October 27, 2009

Re: Comments on Plant Washington draft Prevention of Significant Deterioration (PSD) and 112(g) Case-by-Case Maximum Achievable Control Technology (MACT) Determination Construction Permit No. 4911-303-0051-P-01-0.

Figure 1: Georgia EPD CAMx regional and near-field modeled annual total (primary & secondary) PM_{2.5} concentration impacts due to Plant Washington.

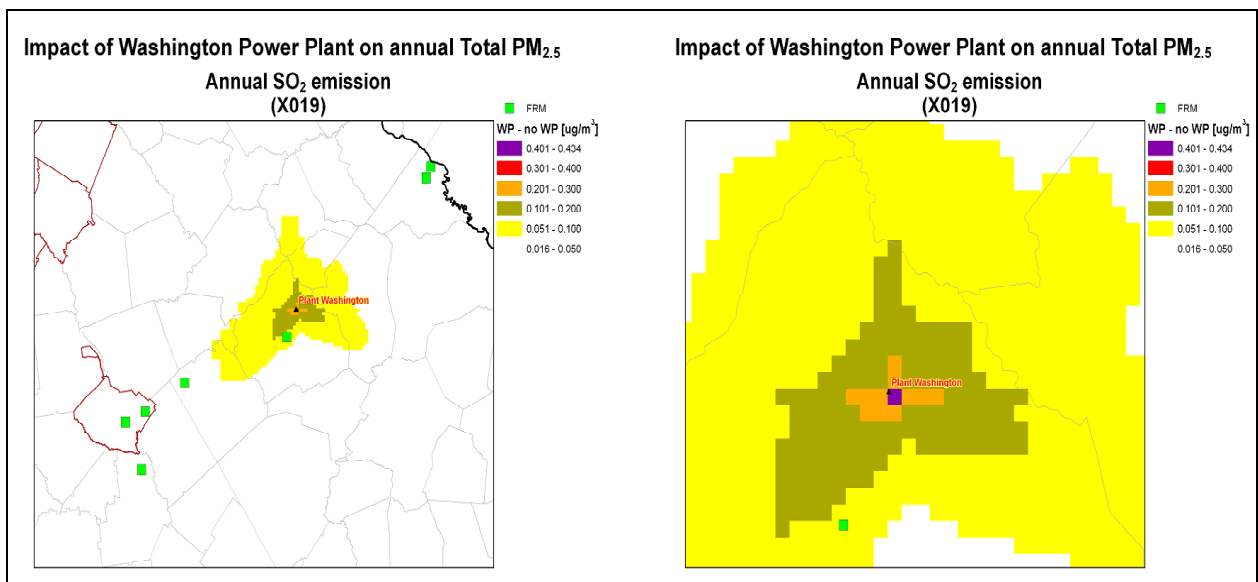
But these results do not fully account for Plant Washington’s PM_{2.5} impacts and do not provide an adequate basis for the Draft Permit. In fact, the full body of evidence in the record refutes Power4Georgians’ claim that Plant Washington’s projected PM_{2.5} and PM₁₀ concentrations will not exceed the PSD SILs. The record includes a draft PowerPoint presentation by Georgia EPD describing CAMx modeling results for Plant Washington, which demonstrates that PM_{2.5} impacts from Plant Washington will exceed SILs and will cause or exacerbate PM_{2.5} nonattainment problems. Ex. 179.¹²⁹ Figures 1, 2, and 3, below, are taken from that presentation. These CAMx modeling results demonstrate that emissions from Plant Washington will produce annual and 24-hour PM_{2.5} increases in large areas that will be greater than PSD SILs, with maximum projected 24-hour PM_{2.5} impacts of 7 µg/m³ near the plant.

CAMx modeling results demonstrate that predicted PM_{2.5} increases from Plant Washington exceed EPA's SILs and exacerbate nonattainment problems in existing nonattainment areas. Ex. 179.¹³¹ On September 21, 2007, EPA proposed SILs for average 24-hour PM_{2.5} impacts ranging from 1.2 to 5.0 µ/m³. Figure 2 from the CAMx modeling presentation demonstrates that modeled 24-hour PM_{2.5} increases from Plant Washington would cause impacts ranging from 1.2 to 2.0 µ/m³ in Newton and Henry Counties in the Greater Atlanta PM_{2.5} non-attainment area and also a small sliver of Bibb County in the PM_{2.5} non-attainment area near Macon. *Id.* Based on the lower range of the 2007 SILs proposed by EPA, the Plant Washington emissions would be predicted to have a significant impact on PM_{2.5} non-attainment in areas already designated as exceeding the PM_{2.5} NAAQS.

Figure 3: Georgia EPD CAMx modeled near-field maximum 24-hour primary & secondary PM_{2.5} concentration impacts due to Plant Washington.

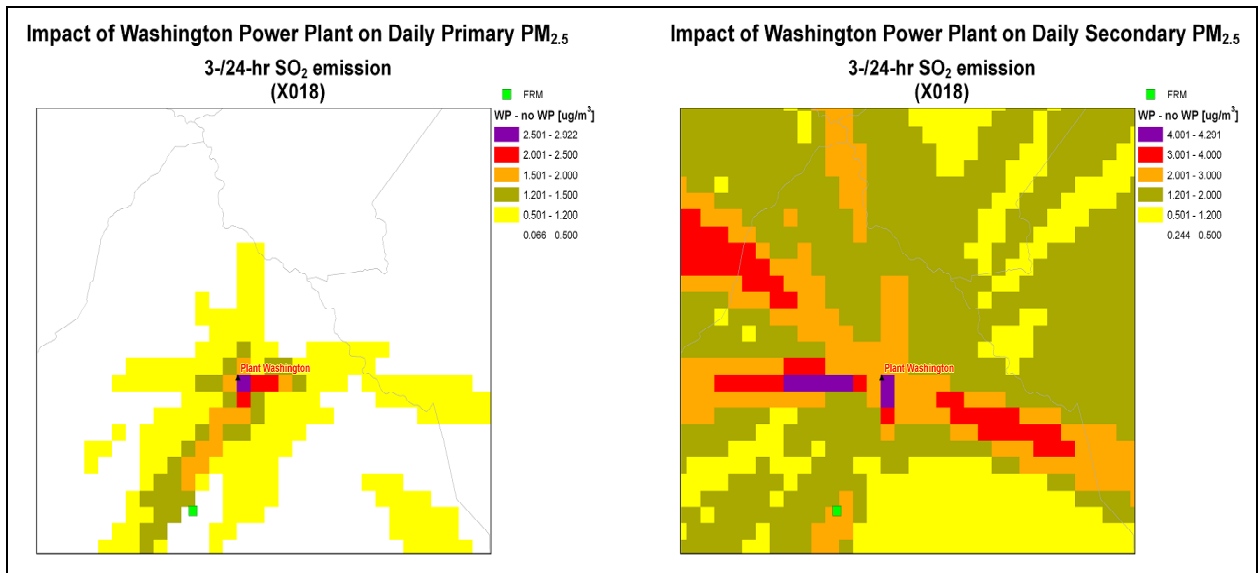
1. Inappropriate meteorological data used in the AERMOD modeling (discussed above); and,
2. The fact that AERMOD does not properly model secondary PM_{2.5} impacts, which are much larger than the primary PM_{2.5} impacts (Figure 3, below).

In light of these discrepancies and the greater predictive values CAMx modeling affords under these circumstances, it would be arbitrary, capricious, and not in accordance with the facts or the law to finalize the Draft Permit, which neither accounts for nor cures the CAMx modeled demonstration that Plant Washington's PM_{2.5} impacts would exceed EPA's SILs and cause or exacerbate existing nonattainment for PM_{2.5} pollution.
